SUBJECT: TURKEY POINT NUCLEAR PLANT, UNITS 3 AND 4 - ISSUANCE
OF AMENDMENTS REGARDING FUEL CRITICALITY ANALYSIS
(TAC NOS. ME4470 AND ME4471)

Amendment No. 246
Renewed License No. DPR-31

Amendment No. 242
Renewed License No. DPR-41

SAFETY EVALUATION BY THE OFFICE OF NUCLEAR REACTOR REGULATION
RELATED TO AMENDMENT NO. 246 TO
RENEWED FACILITY OPERATING LICENSE NO. DPR-31 AND
AMENDMENT NO. 242 TO RENEWED FACILITY OPERATING LICENSE NO. DPR-41
FLORIDA POWER AND LIGHT COMPANY
TURKEY POINT NUCLEAR PLANT, UNIT NOS. 3 AND 4
DOCKET NOS. 50-250 AND 50-251

FIGURE 5.5-3

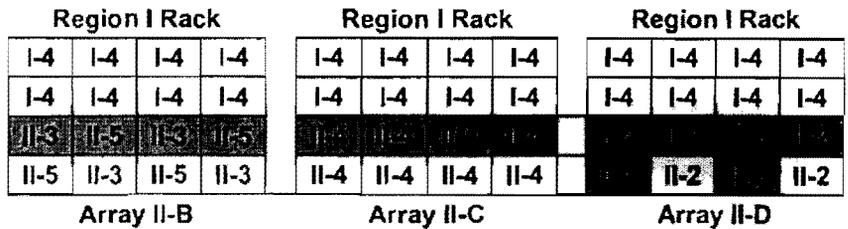
Array II-A, as defined in Figure 5.5-2, when placed on the interface with Region I shall have the empty cell in the row adjacent to the Region I rack.

Arrays II-B, II-C and II-D, as defined in Figure 5.5-2, when placed on the interface with Region I shall have an insert in every cell in the row adjacent to the Region I rack.

5. Attributes for each 2x2 array are as stated in the definition. Diagram is for illustrative purposes only. Region I Array I-B is depicted as the example; however, any Region I array is allowed provided that

- a. For Array I-D, the RCCA shall be in the row adjacent to the Region II rack, and
 - b. Array I-A shall not interface with Array II-D.
6. If no fuel is stored adjacent to Region II in Region I, then the interface restrictions are not applicable.
